Application For Planning Permission

Design and Access Statement for a Peak Container at Marks and Spencer, Holmbush Centre, Upper Shoreham Road, Shoreham-by-Sea, West Sussex BN43 6TD

WEST SUSSEX FIRE AND RESCUE SERVICE
Adur/Worthing Fire Safety Centre
ARDSHEAL ROAD
WORTHING
WEST SUSSEX BN14 7RN
TEL: (01903) 228430
FAX: (01903) 228438
E-mail: wfiresaf@westsussex.gov.uk
Website: www.wscc. co.uk

LEGISLATION: Examination of plans no: SK01 and Regulatory Reform (Fire Safety) Order 2005

05/01 PROPOSED GROUND FLOOR
1:100

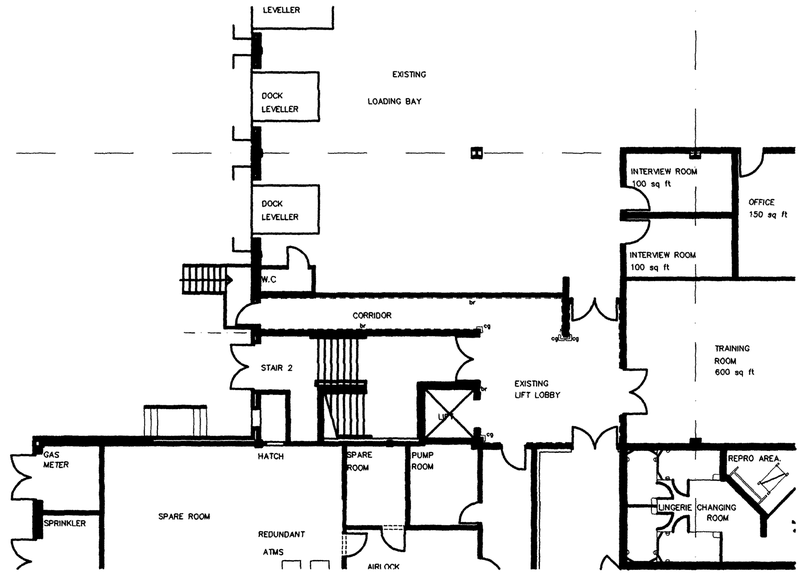
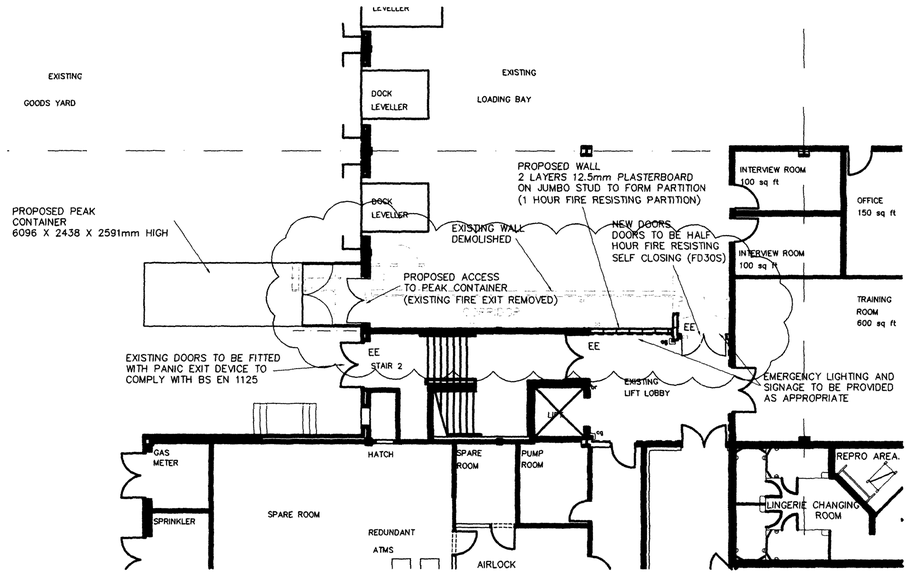
1. A half hour fire resisting partition to be provided as follows:

To include the proposed new corridor wall which encloses the existing lift lobby area double width fire exit (stair 2).

Any doors in the partition to be half hour fire resisting self closing (FD30S).

2. The existing emergency lighting is to be extended to cover the following areas:

New escape route internal and external (adjacent stair 2).

3. A panic exit device, operated by a horizontal bar, complying with BS EN 1125 to be installed on the exits as follows: -

Double doors from stair 2 to open air.

4. All exits to be conspicuously marked with exit signs sited above each of the openings concerned.

NEW PARTITION TO BE 2 LAYERS 12.5mm PLASTERBOARD ON JUMBO STUD. PARTITION TO BE 1 HOUR FIRE RESISTANT

NEW DOORS TO PARTITION TO BE HALF HOUR FIRE RESITING AND SELF CLOSING (FD30S)

EXISTING FIRE EXIT FROM STAIR 2 TO HAVE PANIC EXIT DEVICE, OPERATED BY A HORIZONTAL BAR, COMPLYING WITH BS EN 1125

EMERGENCY LIGHTING AND SIGNAGE TO BE PROVIDE BY NEW ESCAPE ROUTE AND NEW OPENINGS
